DOCUMENT 009113 - ADDENDUM

- A. Project Name: District Office Board Room & 2nd Floor Office Remodel
- B. Owner: Sequim School District No. 323
- C. Owner Project Number: 2023-02-1001
- D. Architect: design2 Last, Inc.
- E. Architect Project Number: 2023-323
- F. Date of Addendum: September 8, 2023

- D. The summary of Addendum #2 changes:
 - 1. Delete reference to E1.0 on the drawing index. There is no sheet E1.0.
 - 2. Note added to sheet E-0.1 deferring any fire alarm redesign scope to Johnson Controls Fire Protection

SHEET NO.
E-1.4

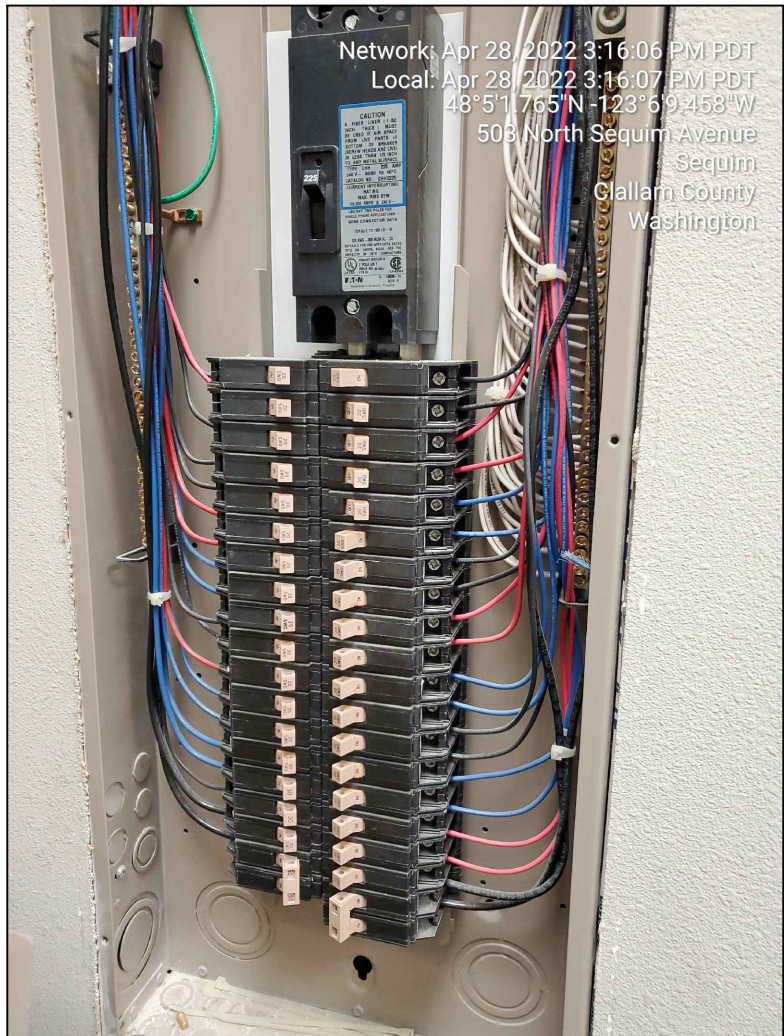
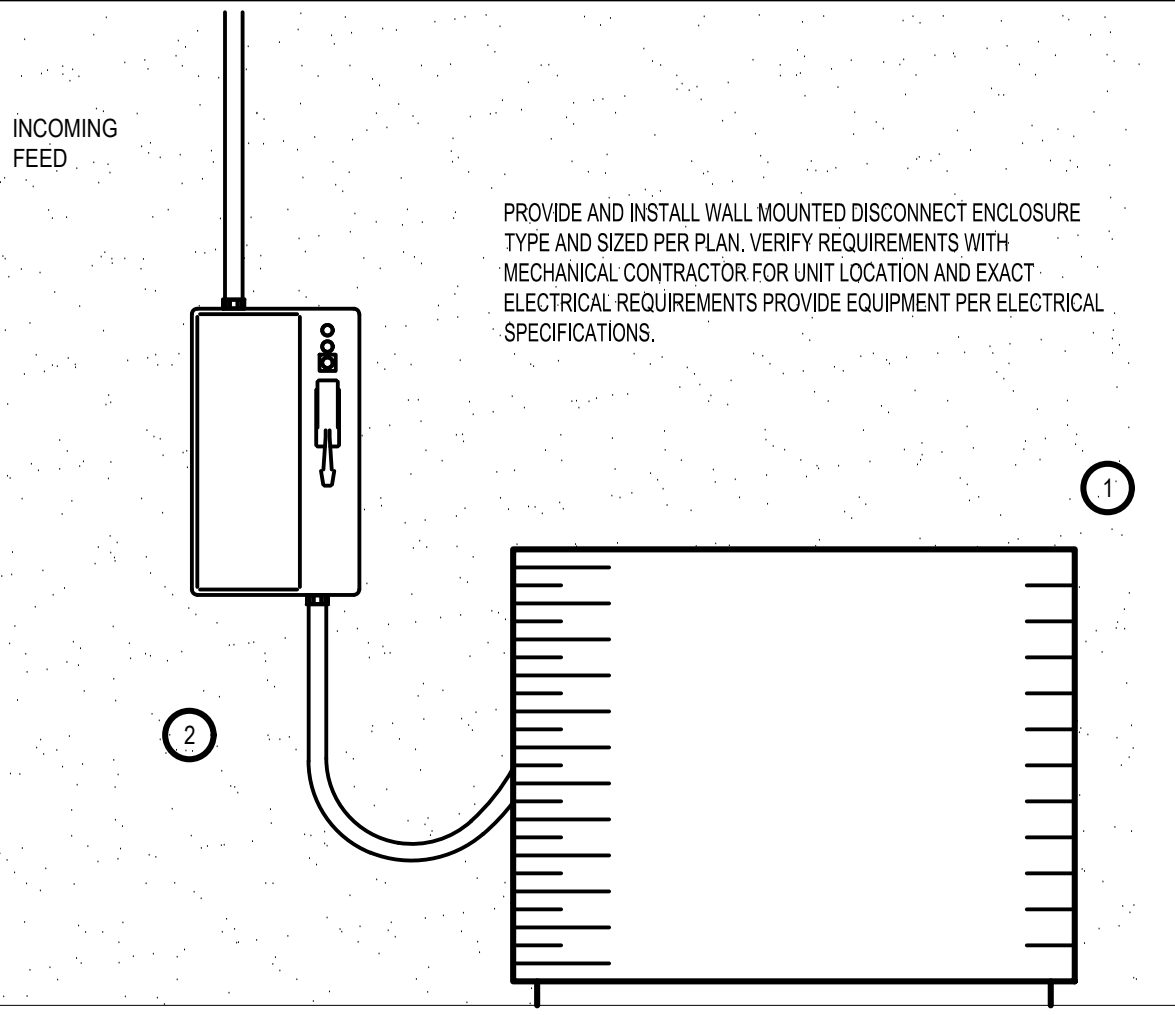
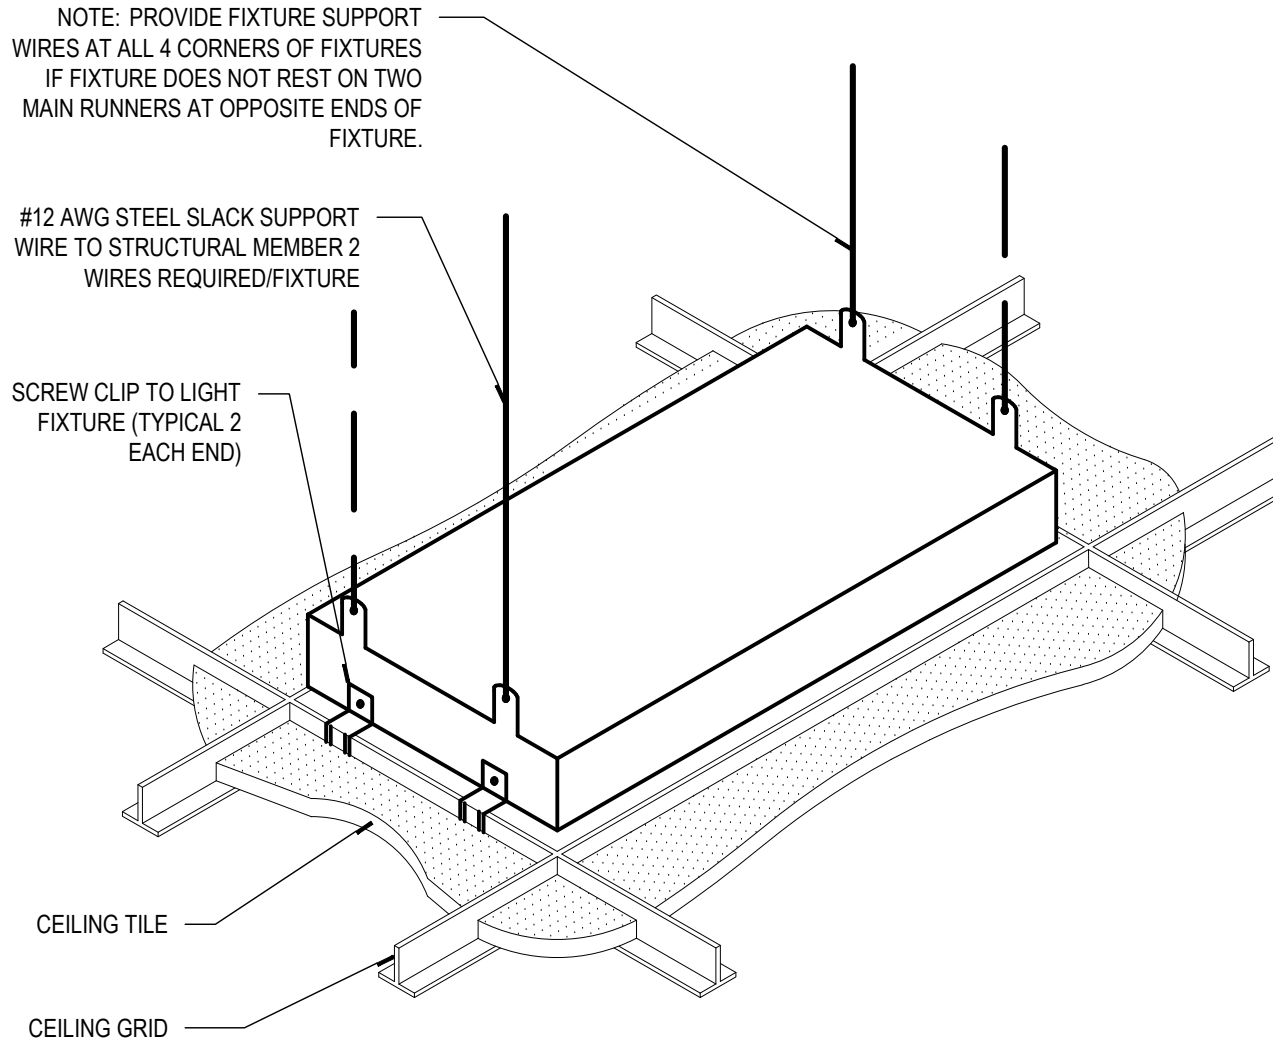
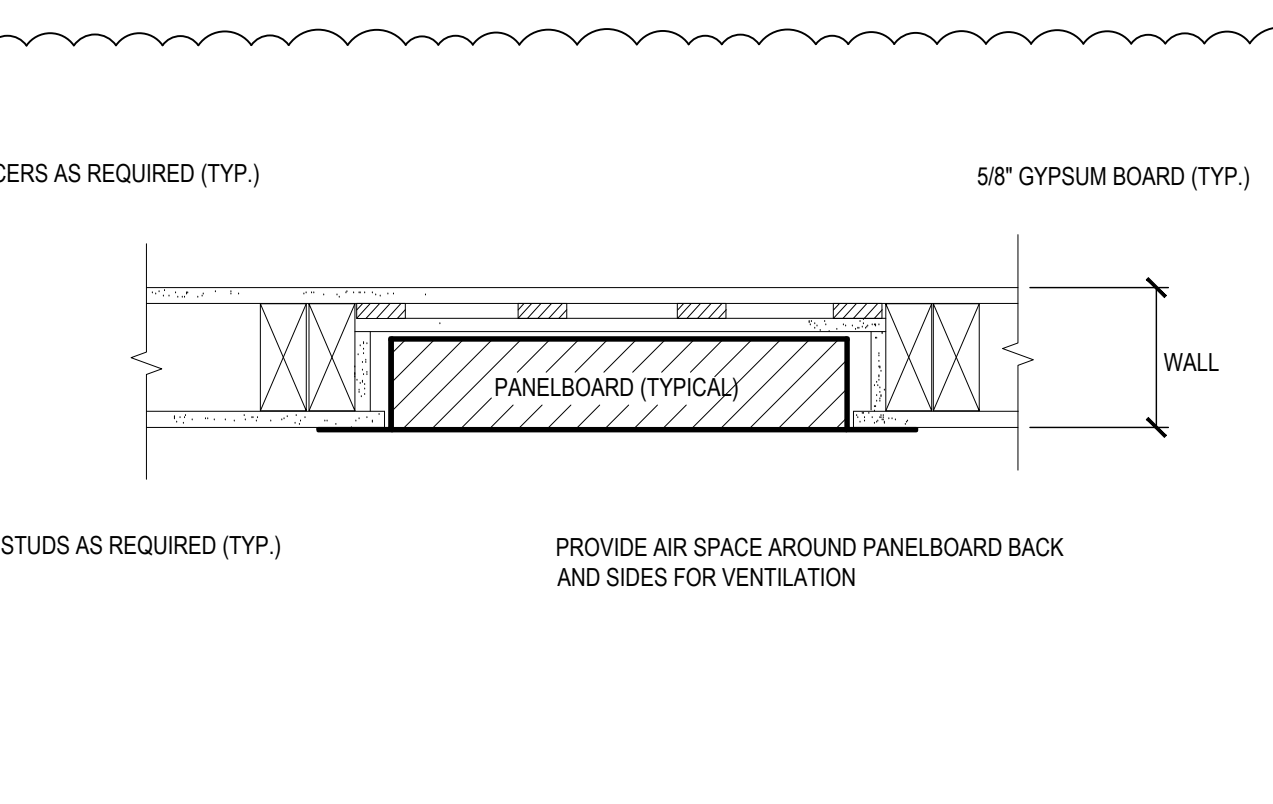
- 3. Fire alarm specifications have been added (E-3.3)
 - 4. Note added to sheet E-1.4 for penetrations to existing building and trenching for added exterior power.

- 1 PROVIDE AND INSTALL NEMA 1 MOTOR RATED SNAP SWITCH.
- 2 CONNECT NEW LIGHT FIXTURE TO EXISTING LIGHTING CIRCUIT WITHIN CORRIDOR.
- 3 PRIMARY SIDELIT DAYLIT ZONE, PER WASHINGTON STATE ENERGY CODE.
- 4 SECONDARY SIDELIT DAYLIT ZONE, PER WASHINGTON STATE ENERGY CODE.
- 5 PROVIDE AND INSTALL 30A 3P H.D. WEATHERPROOF NEMA 3R RATED FUSED DISCONNECT. FUSING PER MECHANICAL EQUIPMENT MANUFACTURERS REQUIREMENTS. VERIFY EXACT LOCATION AND REQUIREMENTS WITH MECHANICAL CONTRACTOR.
- 6 REUSE EXISTING CIRCUIT FOR NEW DRINKING FOUNTAIN. VERIFY EXACT LOCATION AND REQUIREMENTS WITH MECHANICAL CONTRACTOR.
- 7 PROVIDE MINIMUM 3'-0" LEVEL CLEARANCE IN FRONT OF ELECTRICAL EQUIPMENT. PER NEC 110.26.
- 8 CONTRACTOR TO FIELD VERIFY PATH FOR CONDUIT ROUTING. ALL BUILDING PENETRATIONS ARE TO BE WATERTIGHT.
